NRL/MR/7441-94-7546

Digital Mapping, Charting, and Geodesy Analysis Program: Initial Technical Review of Raster Product Format

Digital Mapping, Charting, and Geodesy Analysis Program Technical Review of Raster Product Format (RPF)

Figure 1. Example diagram showing boundary rectangle, frame, and subframe referencing

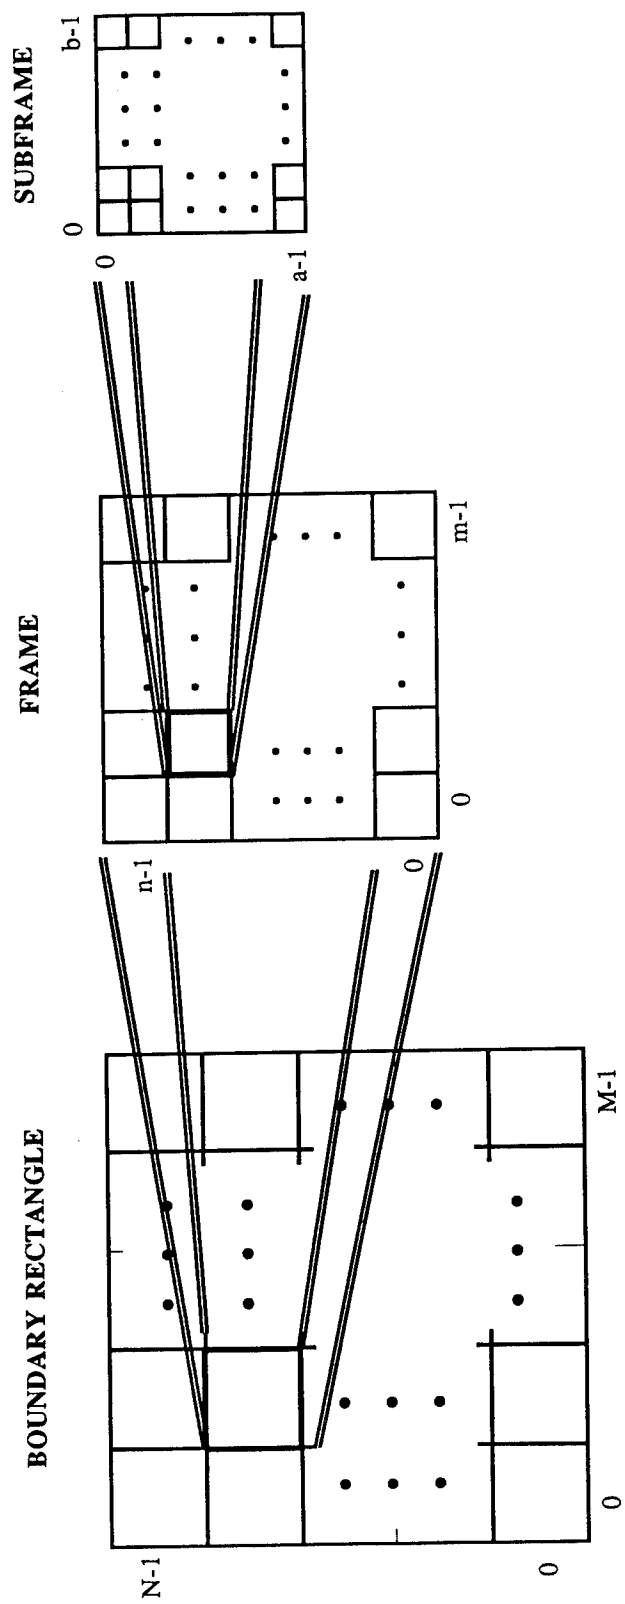
p. 21 How does one distinguish between different boundary rectangles? This question is answered in the diagram on p. 31 (reference each boundary rectangle by the lat/long vertices), but this also needs to be mentioned in the text. Section 5.1.3 on p. 21 since should probably mention this detail, since that is where frame and subframe referencing is described.

p. 21 Different variables should be used to describe subframe size in sections 5.1.3.c.1 and 5.1.3.c.2 since N and M were used to describe frame size in 5.1.3.b.1 and 5.1.3.b.2. A figure (an example is given in Fig. 1) showing the way in which frames and subframes are referenced within boundary rectangles is recommended.
